Customer Legal Recall

(CLR 23-02)

Customer Legal Recall # 662 – U.S. MY23 MC20 Cielo – Windshield frame stud retainment sealant

Figure 1: Image of bare body inserted for illustrative purposes only.

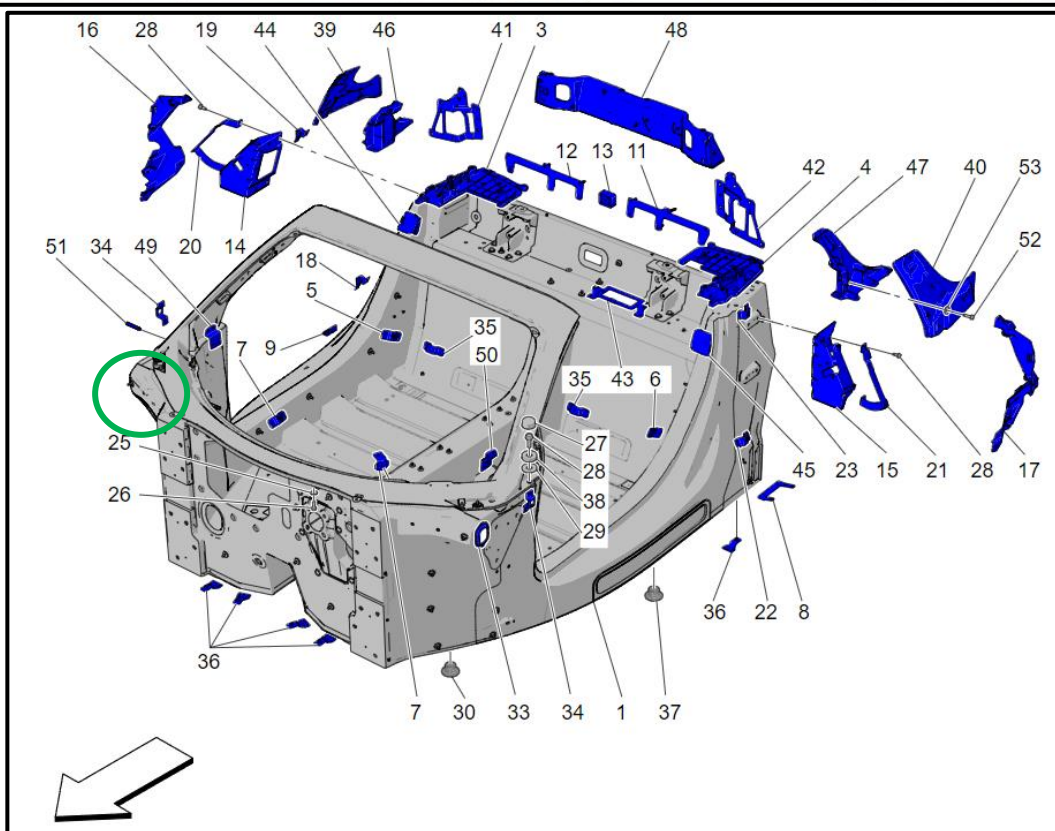
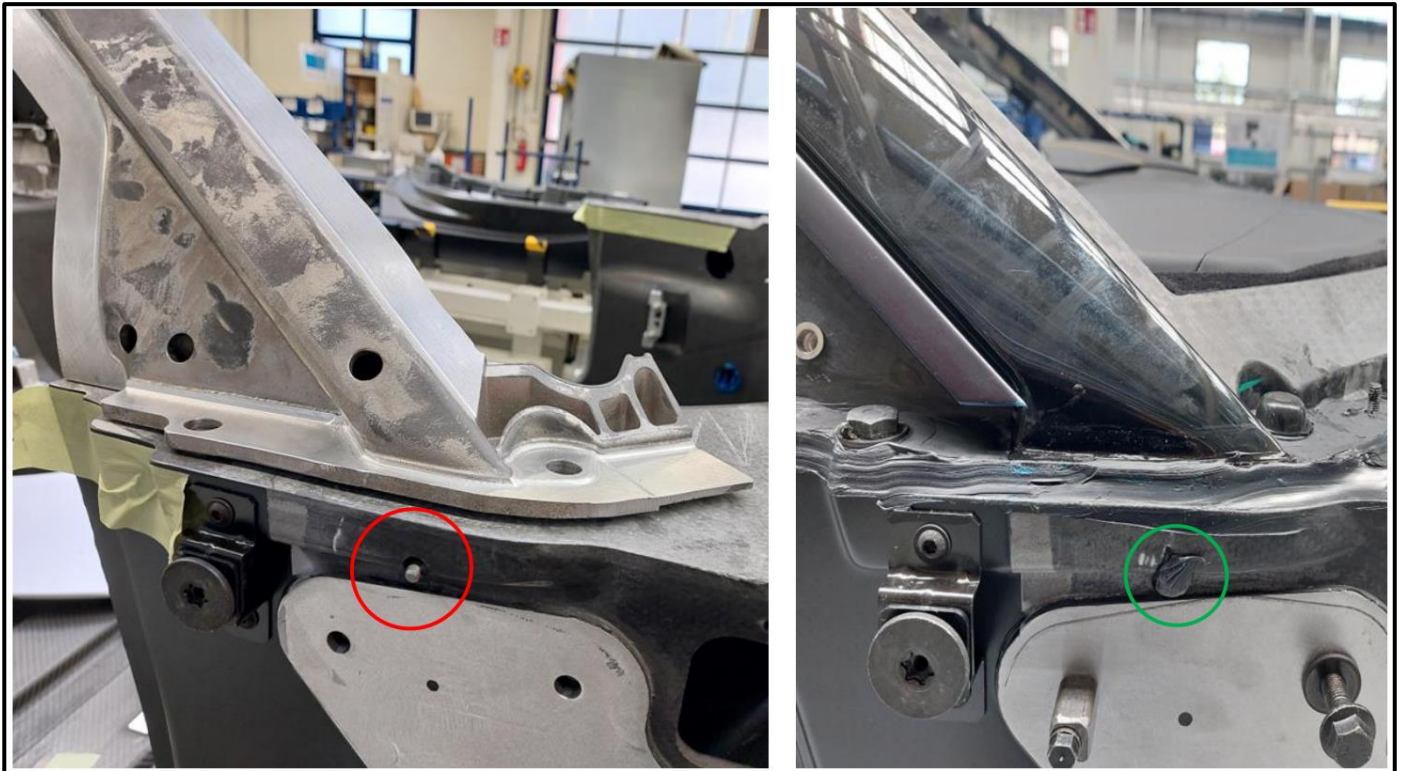
The procedure outlined in this bulletin is essential for verifying the presence of the retaining pin in the windscreen area. The procedure begins with a visual inspection that can either confirm or negate the existence of both the sealant and the corresponding pin.

The presence of the pin can be easily verified using a mirror or an endoscope. The sealant is a guarantee of the correct assembly procedure of the component, while the possible presence of the pin alone is to be considered non-compliant and therefore

requires reworking. Reworking consists of inserting the pin (PN 670220781) and sealing the area with a special sealant.

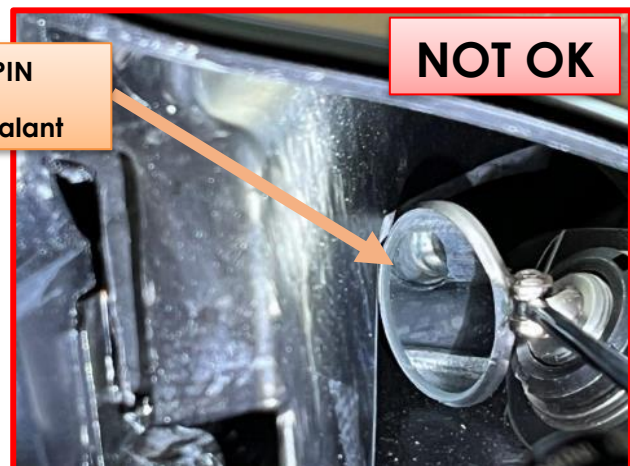
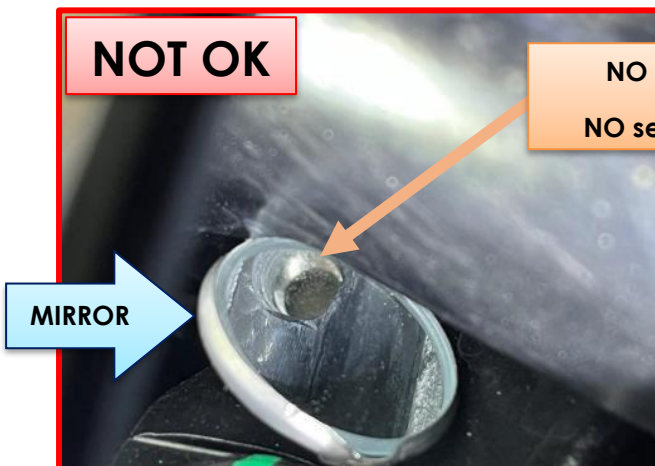
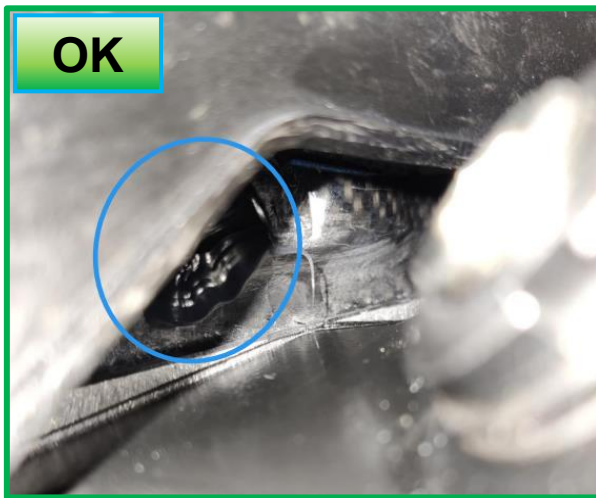
1. Prepare the vehicle for the work by arranging all the protections to avoid any damage to the bodywork and internal parts of the vehicle.
2. Open the door and, working in the door hinge area, use a mirror or endoscope to visually check for the presence of the sealant in the indicated location.

Note: After checking with the mirror, as a double check, also check the presence of the sealant by inserting your hand directly and checking the area of the A-pillar with a finger. **Attention:** This type of check is not a substitute for the mirror check.

3. **Check the presence of the sealant and the backup pin.** Refer to the images below if in doubt.

- **OK** ► SEALANT IS PRESENT; the procedure is finished. No further action needed.
- **NOT OK** ► SEALANT AND OR THE PIN IS MISSING; the car is non-compliant and must be reworked. Continue with the rework procedure on the next page.
